# CALIFORNIA CROSSROADS

Stage 3 Road Safety Audit

**REPORT NUMBER: UK-70104511/RSA3/1/0**

**DATE: JANUARY 2025**

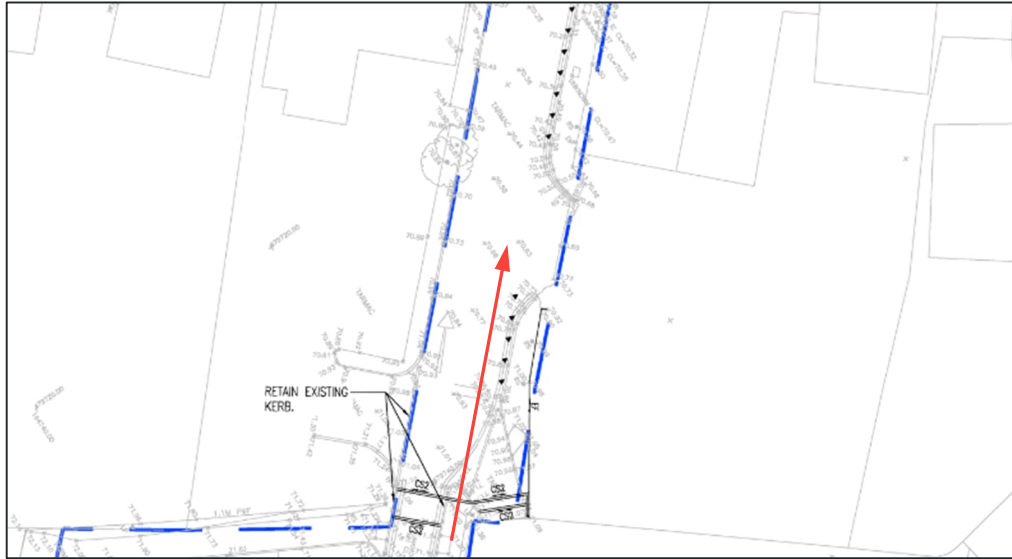
It was observed during the site visit that the “New Road Layout Ahead” traffic sign on this approach to the junction was partially restricting the visibility of the adjacent map-type advance direction sign. Therefore, this problem remains relevant.

Accepted: Temporary sign to be moved to a more appropriate location, as shown below.

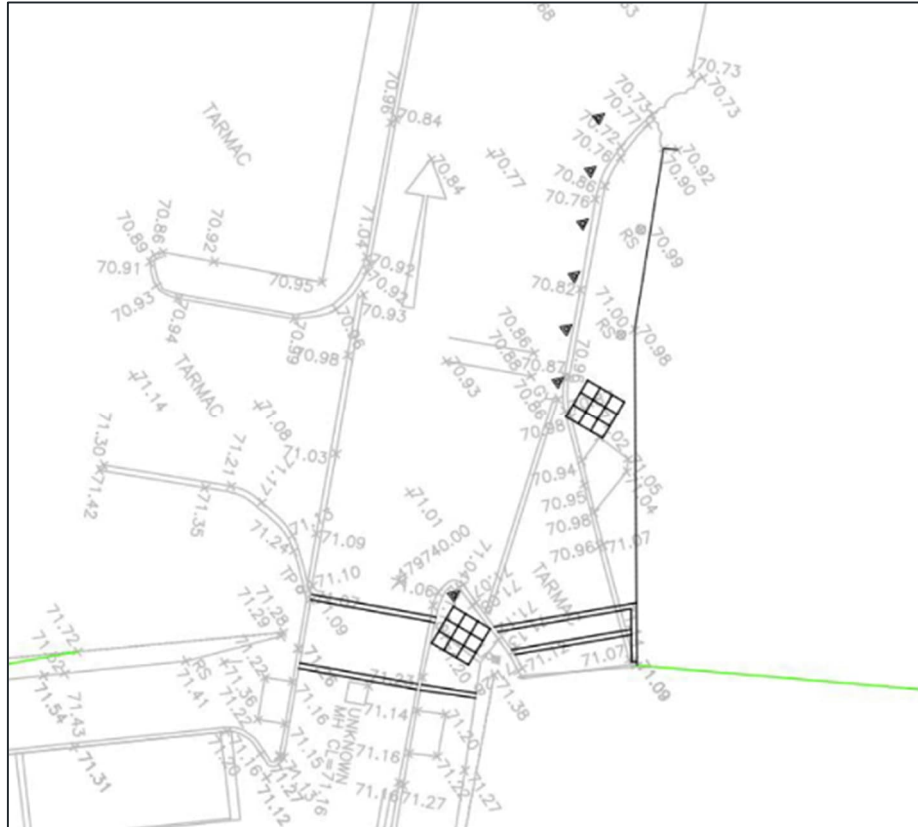
In the proposed layout, visually impaired pedestrians walking from the car park footway could mistakenly walk straight ahead onto the access road carriageway (as the northern end of this footway will be flush with the carriageway surface) and potentially into the path of a vehicle travelling towards the car park – see example below. This could lead to a visually impaired pedestrian being struck by a vehicle on the carriageway.

*It is recommended that an appropriate feature is provided in this location, such as tactile paving, in order to direct visually impaired pedestrians from the car park footway towards the north-east side of the access road, so that they will walk behind the proposed bollards rather than into the path of an oncoming vehicle.*

*Accepted. Design has been updated to include a bollard to aid visually impaired pedestrians to keep right as they travel north as well as tactile paving to direct them across the residential access. The shared surfacing will be extended onto part of the footway in the car park to ensure appropriate contrast between the tactile paving and the surface paving treatment. Alignment shown below:*

LOCATION PLAN OF ROAD SAFETY PROBLEMS

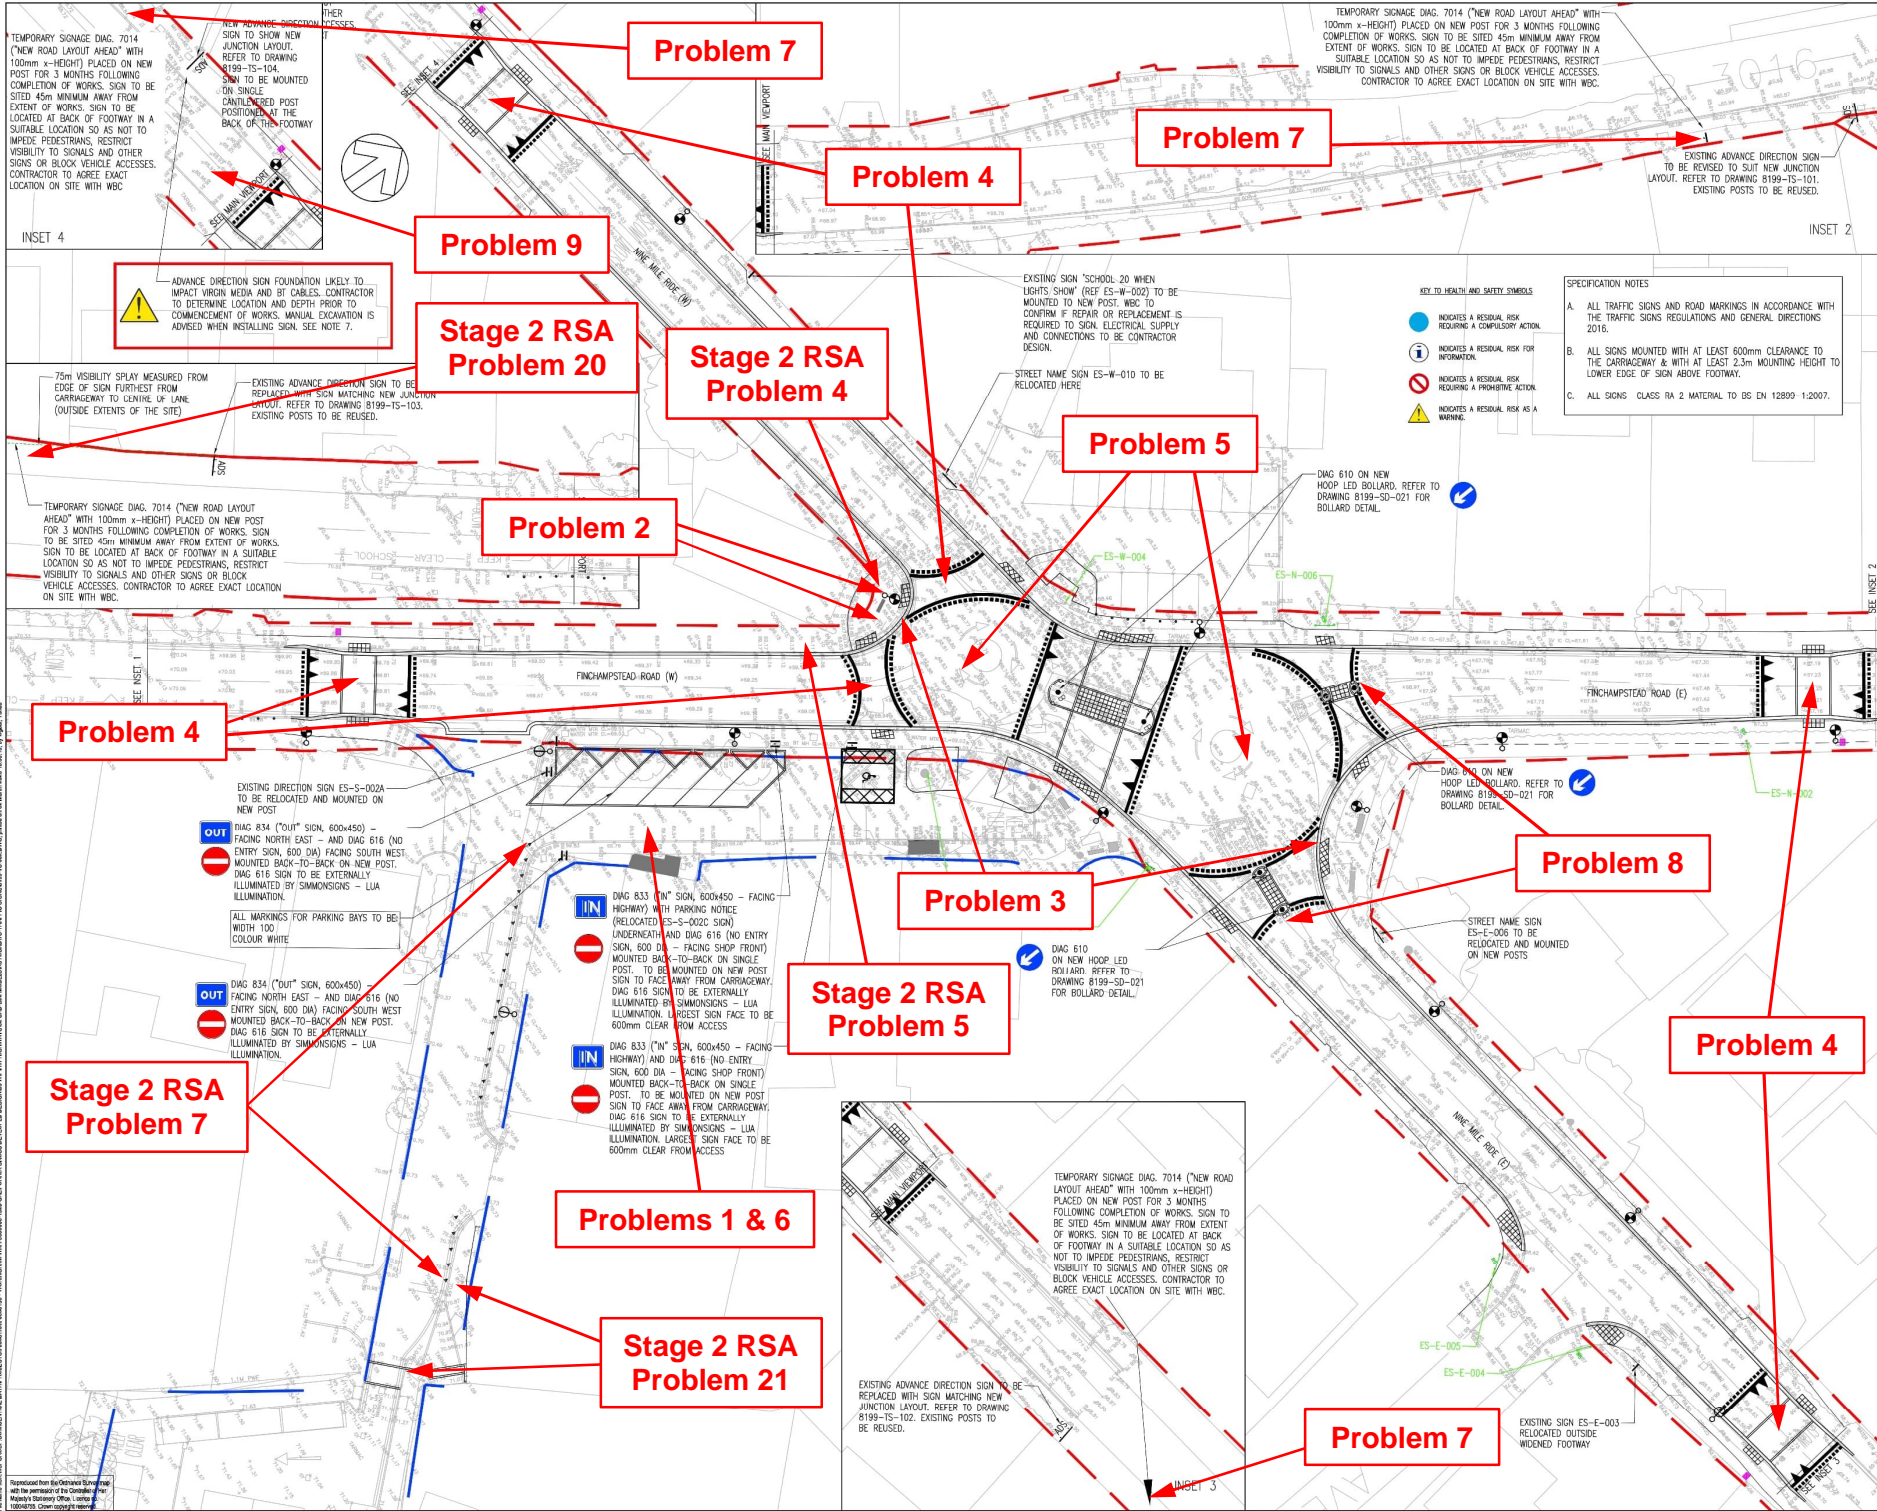
Location: Parking area for the shops on the south side of the California Crossroads junction – see Appendix B for location.

Summary: Removal of the footway could increase the possibility of conflicts between pedestrians and vehicles in the parking area.

Location: South-western corner of the California Crossroads junction – see Appendix B for location.

Summary: Petrol station signage could present an obstruction on the footway as well as further restricting the visibility to / from the adjacent pedestrian crossing points.

Locations: South-western and north-eastern corners of the California Crossroads junction – see Appendix B for locations.
